Response to Reviews

R1-1: This paper presents a new objective function for automatic calibration of 3D hydrodynamic models based on water temperature and velocity data. The case study is a tropical lake, where the authors tested their DYNO+PODS for calibrating a Delft3D model against a subset of previously simulated 3D flow and temperature fields from a run assumed to be the "truth". I strongly appreciate this approach as it provides the full control of the optimization. Moreover, as the authors stressed many times (maybe too many, a lot of repetitions could be avoided), the use of velocity data together with water temperature is not so diffused yet in the field of lakes hydrodynamic modeling but it is crucial to have consistent results and realistic flow fields. Hence I welcomed the author's effort in quantifying how important it is.

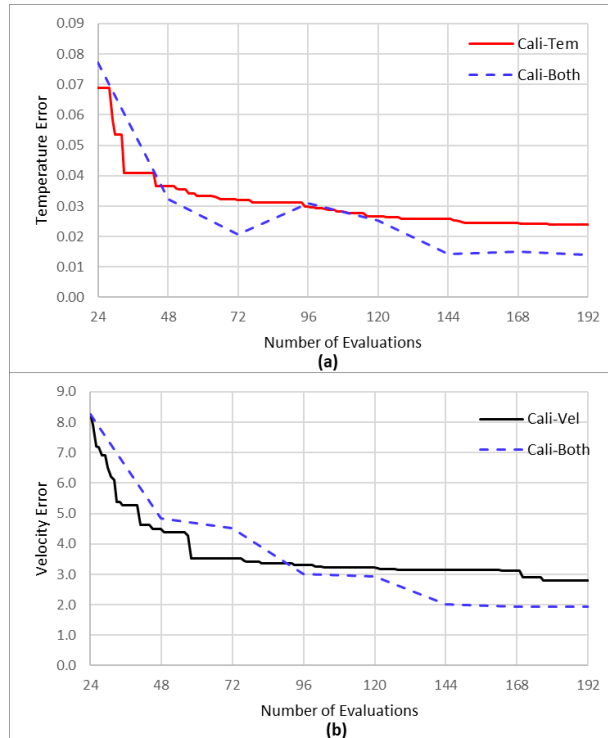
Computational costs: Addressing this aspect is mandatory in a paper on optimization algorithms. The authors make some general considerations here and there, but maybe a dedicated paragraph would be more appropriate. My questions: How many (real) runs of the hydrodynamic model were necessary to get the final solution for e.g. each trial/each configuration of Dyno (temp, vel, both)?

What is the computational cost (wall clock time) of these tests? e.g., how much time compared to the error?

Response: Our study set the same evaluation budget (i.e., the maximum number of hydrodynamic model runs) for each trial and calibration scenario (i.e., Cali-Tem, Cali-Vel, and Cali-Both). The maximum number of hydrodynamic model runs in each trial is 192, which is about 8 iterations with 24 evaluations in each iteration. The result indicates that 8-iterations is a sufficient budget as the calibration progress plot in Figure R1-1 shows the optimization experiments almost converged in the last few iterations.

The computational time of one simulation is approximately 5 hours on a windows desktop with CPU Intel Core i7-4790 processor. However, when running 24 simulations simultaneously on a multi-core platform, the computational time gets longer because of the limited cache memory resources (as discussed in Xia and Shoemaker (2022)). Cache memory is a small amount of much faster memory than main memory. The wall-clock time for one iteration with 24 cores simultaneously running is about 12 hours if using the default process scheduling of the nonuniform memory access (NUMA) multi-core system. We used the mixed affinity scheduling proposed by Xia and Shoemaker (2022), and the wall-clock time is reduced to about 8 hours per iteration. The mixed affinity scheduling changed the default affinity setting by setting a hard affinity on the simulation of each PDE model (i.e., fixing the process of each PDE simulation to one core). This approach proved to be efficient for memory usage and reduced the simulation time. More details about the mixed affinity scheduling and the NUMA system can be found in the study of Xia and Shoemaker (2022). Hence, the wall-clock time of each trial takes about 64 hours (8 iteration \times 8 hours/iteration).

We have added a separate paragraph in the end of section 2.7 of the revised manuscript as suggested by reviewers to discuss the computational cost of the experiments and we have also added the calibration progress plot (Figure R1-1) in the supplementary materials (as Figure S1).

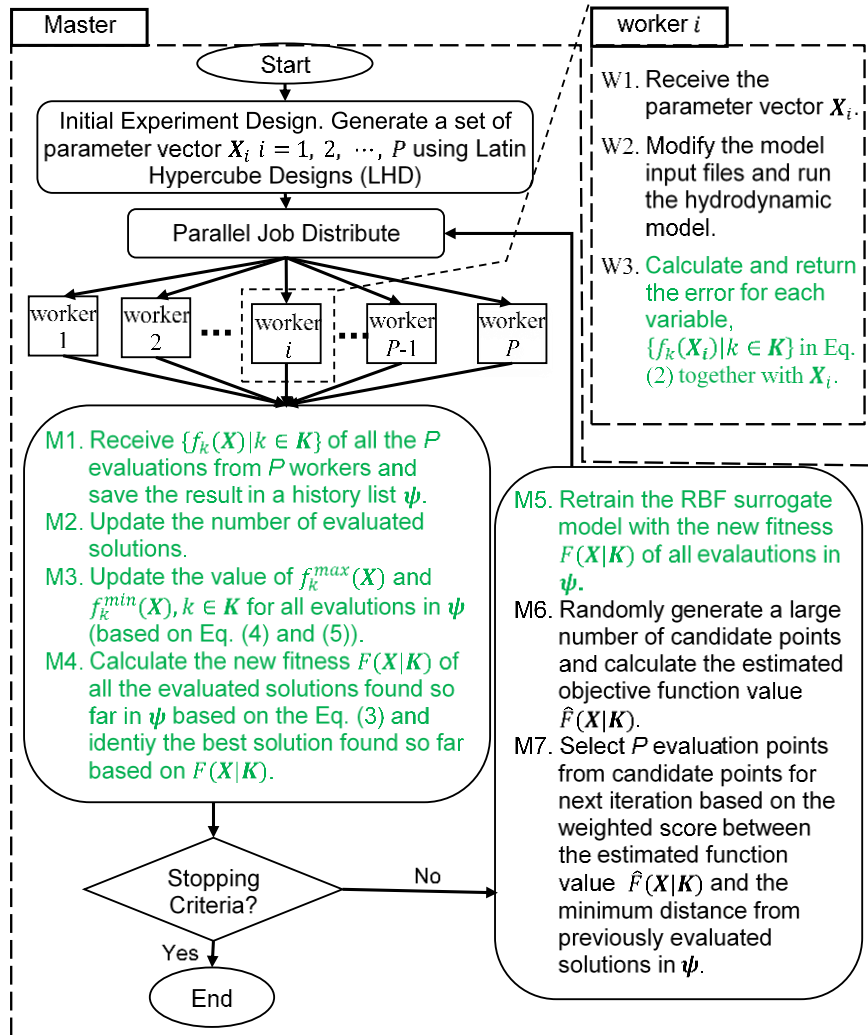
R1-29: Sect.2.6.1. This paragraph seems like an advertisement of PODS and is highly technical. I'm not sure it is adequate to the wide audience of HESS. The authors could consider limiting the acronyms to those that are really needed (e.g. do we really need to know that “DYCORS inherits the dynamic coordinate search idea from DDS (Tolson and Shoemaker, 2007) to improve its effectiveness and efficiency for high dimensional problems”?) and try to clarify a bit. What does RBF surrogate mean? Maybe the authors could consider merging sect 2.6.1. and 2.6.2. and try to explain things in easier terms (and referring to publications for high-technical details), eventually splitting some very long sentences.

Response: After one iteration is finished (e.g., the simulation of the P hydrodynamic simulations). The objective function value $F(X|K)$ of all evaluations in ψ (including the newly finished

evaluations in this iteration and previous iterations) are recalculated. The RBF surrogate model is rebuilt with the new objective function value $F(\mathbf{X}|\mathbf{K})$ that are calculated based on Eq. (3). The newly built RBF surrogate model is then used for selecting the evaluation points for the next iteration. In PODS, the algorithm first generates a large number of candidate points around the best evaluation found so far. Then P evaluation points are selected from the candidate points using a Surrogate-Distance Metrics discussed in the PODS paper. The metrics consider the approximated objective function value based on the surrogate model and the distance of the evaluation points from the evaluated points. We have revised lines 318-320 (in original manuscript) by adding more explanations.

To reviewer's question 2), the tasks of P workers are independent of each other (i.e., each worker evaluates one hydrodynamic model). The steps M1-M6 are master's tasks, performed after the tasks of P workers are finished in each iteration. So each worker sends back to the master the results of one simulation (i.e., temperature and velocity error of one evaluation). Then the master adds all these newly obtained results to the history list ψ , which contains the results of all evaluated points in previous iterations. M1-M7 only need to be performed on one processor. The jobs of M1-M7 is to generate P evaluation points and then distribute the P evaluation points to P processors for the workers' tasks. The master M7 distributes the P evaluation points randomly to the P processors so each processor will get an evaluation point and send back the evaluated results to master. We have modified the Figure 2 in the original manuscript as below Figure R1-2 to make it clear.

Figure R2-1. The parallel axis plot for the parameter value and the composite error of temperature and velocity of calibration solutions under different scenarios (Cali-Tem, Cali-Vel, and Cali-Both). True solution defined in Table 2 is given for reference.

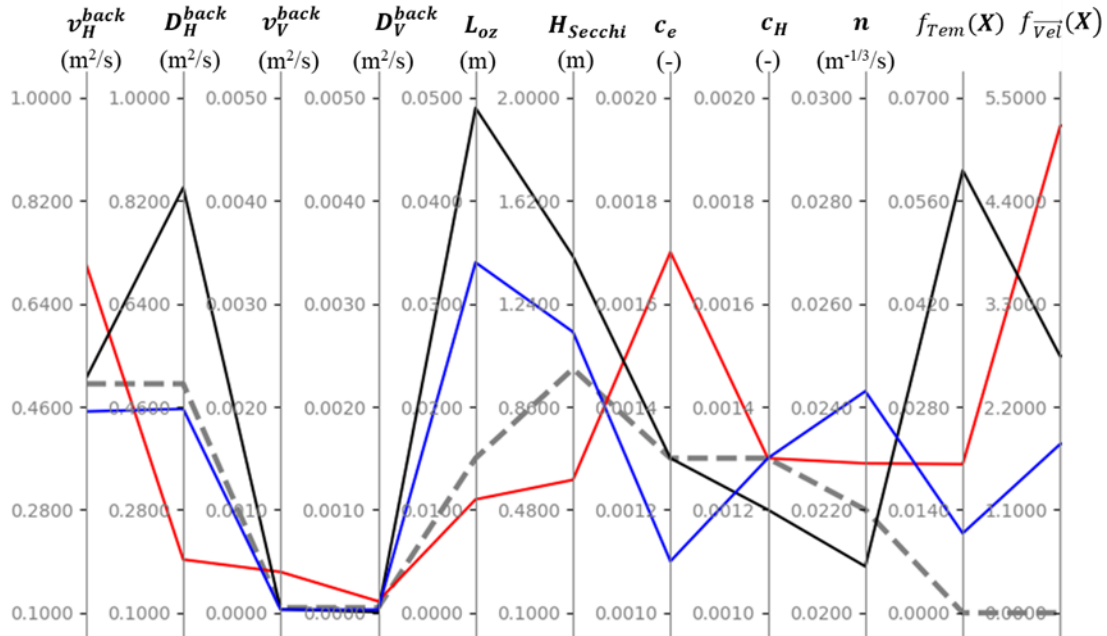
R2-7: 5. The authors should provide some discussion about the physical meaning of the errors in the results. For example, the Ozmidov length scale in the "true solution" is 0.015, but the "best" calibration has more than double this value; at the same time, the background vertical diffusivity in the calibration is about 3/5 of the true value and the Secchi depth is overestimated by 13%. These all exert controls on vertical mixing, and the wide disparities for different calibration methods makes me question as to whether calibration can really be effective to capture the complex, time-varying behaviors of vertical mixing in a stratified system with the given turbulence model. I do not expect the authors to solve such a problem, but I think they should discuss the implications. Replacing Table 5 with a well-constructed bar graph (with appropriate normalization) would help the readers see which parameters are doing all the work.

Response: It is always challenging to explain the physical effect of parameter error when multiple parameters are being calibrated simultaneously. The relation between parameter value and the simulation results is nonlinear, and it becomes more complex when multiple parameters interact with each other. The reviewer has quantified the difference in “actual” parameter value and “best” parameter value obtained from calibration as a percentage. This might give the impression that the solution is very inaccurate. We are not sure if it is meaningful to look at the parameter error in percentage since some of the parameters value are very small; hence it might lead to a large percentage value when dividing the parameter error by the parameter value. In addition, the solution is obtained with a limited computing budget. Hence it is difficult to find the exactly true solutions in such a limited computing budget. We think it might be more meaningful to visually compared parameter sets values of different calibration scenarios with the true parameter set. Our goal is to show that calibrating to both temperature and velocity gives a better solution than calibrating to one of them. Figure R2-1 below shows the parameter value of solutions under different scenarios. The parameter value of the solution in calibrating to both is generally closer to the true solution than the other two cases.

In our revised manuscript, We have replace Table 5 with Figure R2-1 below. We have put Table 5 into supplement since some reader might prefer to see table than figure. We have added the discussion of the parameter error in the section 3.1.2: “*The objective function value in terms of temperature and velocity composite error (over multiple locations) ($f_{Tem}(\mathbf{X})$ and $f_{\overline{vel}}(\mathbf{X})$), as formulated in Eq. (7) and (10), respectively) and the corresponding parameter configuration (\mathbf{X}^*) of the selected solution (among three trials) are plotted in Fig. 5 and reported in Table S1. In general, the solution in the Cali-Both scenario is closer to the True solution than solutions in other two scenarios. The solution in the Cali-Both scenario is closest to the True solution at four parameters (i.e., \mathbf{D}_H^{back} , \mathbf{D}_V^{back} , \mathbf{H}_{Secchi} , \mathbf{c}_H). In addition, besides the Manning coefficients, the solution in the Cali-Both scenario is not the worst at any parameter. In contrast, solution in the Cali-Tem in worst at five parameters (i.e., \mathbf{v}_H^{back} , \mathbf{D}_H^{back} , \mathbf{v}_V^{back} , \mathbf{D}_V^{back} , \mathbf{c}_e) and solution in the Cali-Vel is worst at \mathbf{L}_{oz} , \mathbf{H}_{Secchi} , \mathbf{c}_H . This indicates that calibrating to both temperature and velocity can help to prevent very bad value of the 9 calibration parameters.*” (line 444-452 in the revised manuscript)

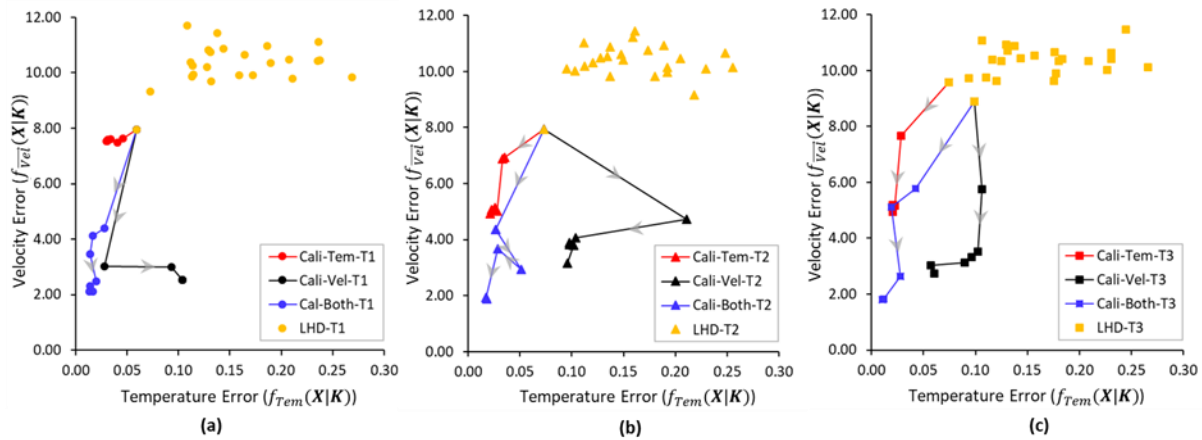
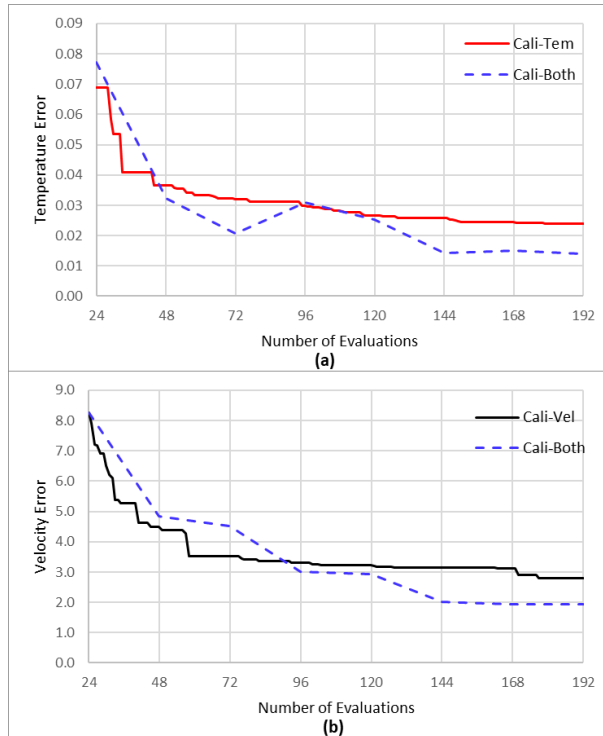
R3-3: This comment is somehow related to the previous one. In theory it should be possible for the search algorithm to identify the "true" parameter set that was used to generate the synthetic observation data. This global minimum is present on the parameter response surfaces of all three calibration scenarios and has a value of 0 independent of the used metric (DYNO or the single performance metrics). Thus, when not ending up in a local minimum all three cases should converge towards this

Response: The reviewer brings up an interesting aspect to discuss. In theory, the global minimum has a value of 0 for all three calibration scenarios. However, it might not be correct that having zero temperature error at these observation locations would mean zero velocity error at these observation locations. This is because only the observation at part of the simulation space is used for calibration (not the observation data at each grid and each time step of the simulation space are used to calculate the temperature error). So the temperature error may be 0 at these observation locations, while the temperature error is not 0 at other locations where observation is not used in calibration. In this case, getting a temperature error 0 at observation locations cannot guarantee the velocity error is 0. Hence it is possible that the optimization ends up in a local minimum and does not converge towards the global minimum (both temperature and velocity error are zero) in cases calibrating to only temperature or velocity.

In optimization search, the algorithm might not even reach the solution with zero temperature or velocity error when calibrating to only one variable. This is because the optimization only focused on one variable (temperature or velocity) and ignored the calibration on another. For example, if only calibrated to temperature, the velocity error might still be large. In this case, the algorithm is less likely to find the solution with temperature error 0 while the velocity error is large. This is exactly what Figure R3-1 showed (We copied Figure 6 (a) in the revised manuscript below). In Figure 6 (a), when calibrating to temperature only, the best solution found after each iteration is converged at places where the velocity error is large, and temperature error is not reduced to 0. In contrast, the optimization search considered both temperature and velocity error when calibrating to temperature and velocity. Hence the best solution found after each iteration is improved in both temperature error and velocity error.

The reviewer asks for experiments with a large number of iterations. We did not increase the number of iterations because, 1) we found the optimization search almost converged at the last few iterations (As shown in the calibration progress plot Figure R3-2 below) and 2) our problem is computationally very expensive; one single simulation takes about 5 hours; 24 simultaneous simulations take about 8-12 hours because of limited memory resources. It takes more than 64 hours to conduct one calibration experiment, and we have three scenarios, and each scenario is repeated in three trials. This is a huge amount of computing. Meanwhile, in real practice, users are also unwilling to wait too long for the calibration process. That is why we compared the accuracy of the solutions within a limited computing budget.

In the section 3.2 of revised manuscript, we have added: "... As discussed in experiment setup section, we conducted 8 iterations of the optimization search. This is a reasonable number of iterations for our case given that 1) the problem is computationally expensive (one experiment takes about 64 hours to run and there are 9 experiments) and 2) the calibration progress plot in iterations (Figure S1) indicates that the optimization search almost converged in 8 iterations." and "... Figure 6 also shows that when

calibrating to one variable, the optimization search is easily convergent (i.e., the best solution does not continue improving after few iterations even in terms of the fit of the variable considered in calibration). For example, in Fig. 6(a), when calibrating to temperature only, the best solution in in terms of temperature error does not improve much (in the last few iterations). The reason might be that when the velocity error is large, it is less likely that the temperature fit would be improved further. In contrast, when calibrating to both temperature and velocity, the optimization search continues improving in both the temperature and velocity fit. Hence only considering one variable in the calibration, it is difficult to get a solution that have small (or close to zero) error of the variable considered. We should also highlight that even though the optimization get a solution that has zero error in one variable, it does not mean that the error of another variable would be zero. The reason is that only the observation in part of the simulation space is used for calibration (not the observation data at each grid and each time step of the simulation space are used to calculate the temperature error). So the temperature error may be 0 at these observation locations, while the temperature error is not 0 at other locations where observation is not used in calibration. In this case, getting a temperature error 0 at observation locations cannot guarantee the velocity error is 0...” (ine line 543-556 of the revised manuscript)
